Well information: 30-043-21175, Lybrook M28-2306 2H, Encana, M 28-23N, 6W

SUNDRY NOTICES AND REPORTS ON WELLS
**Do not use this form for proposals to drill or to re-enter an
abandoned well. Use Form 3160-3 (APD) for such proposals.**

8. Well Name and No.
Lybrook M28-2306 02H

Project: Sandoval County, NM
 Site: Lybrook
 Well: Lybrook M28-2306 02H
 Wellbore: Hz
 Design: Plan #3

WELL LOCATION AND ACREAGE DEDICATION PLAT

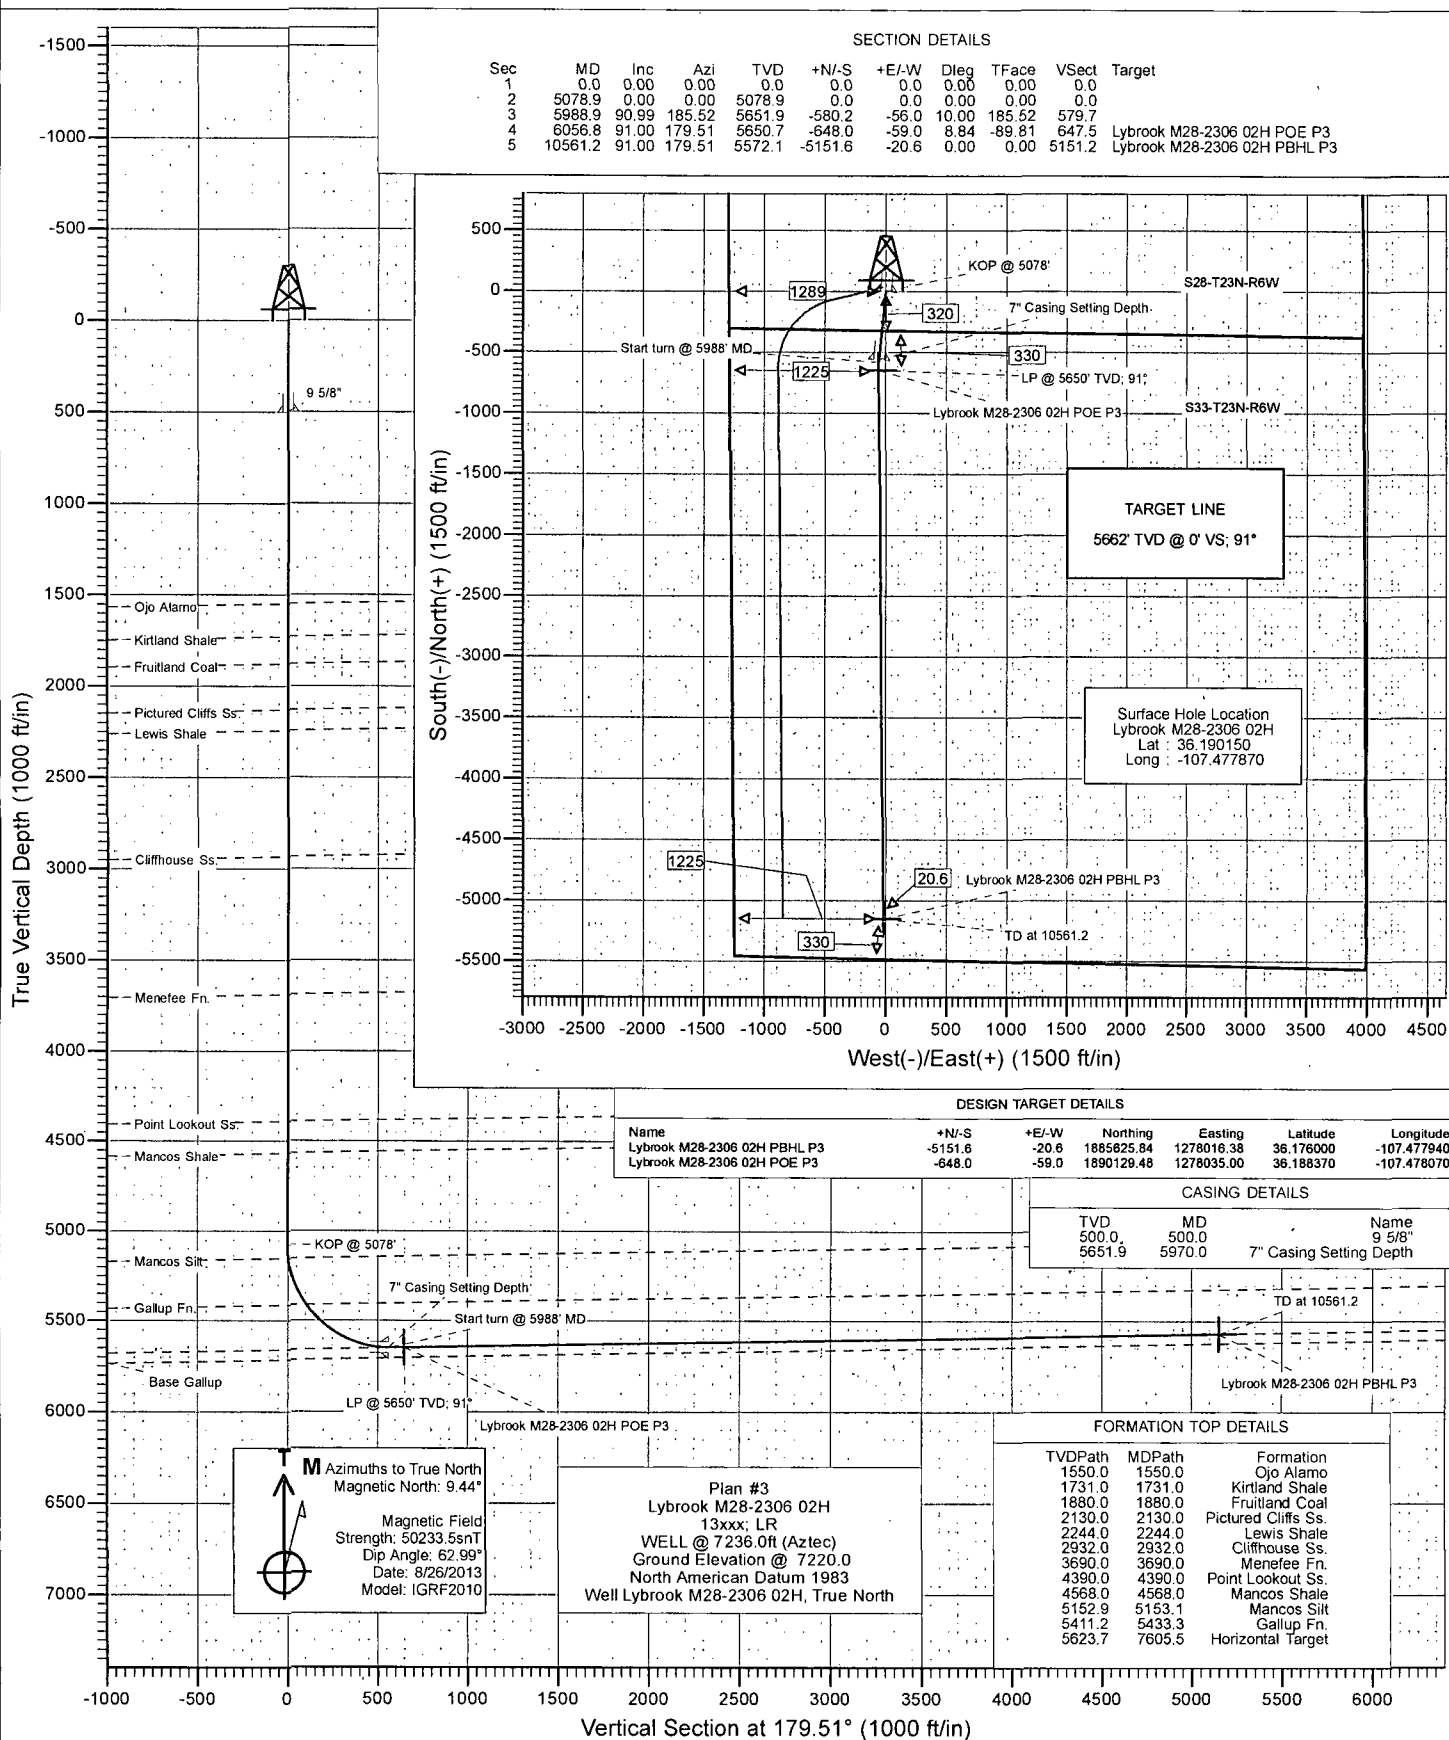
Encana Oil & Gas (USA) Inc. (Encana) would like to move the SHL for the Lybrook M28-2306 01H to 320'FSL and 1289'FWL Sec 28, T23N, R6W and the BHL to 330'FSL and 1225'FWL Sec 33, T23N, R6W. (Original SHL was 349'FSL and 1295' FWL Sec 28, T23N, R6W. Original BHL was 330'FSL and 1875' FWL Sec 33, T23N, R6W.) This will change the TD of the well from 10805'MD to 10561'MD and the kick off point from 5002' to 5078'.
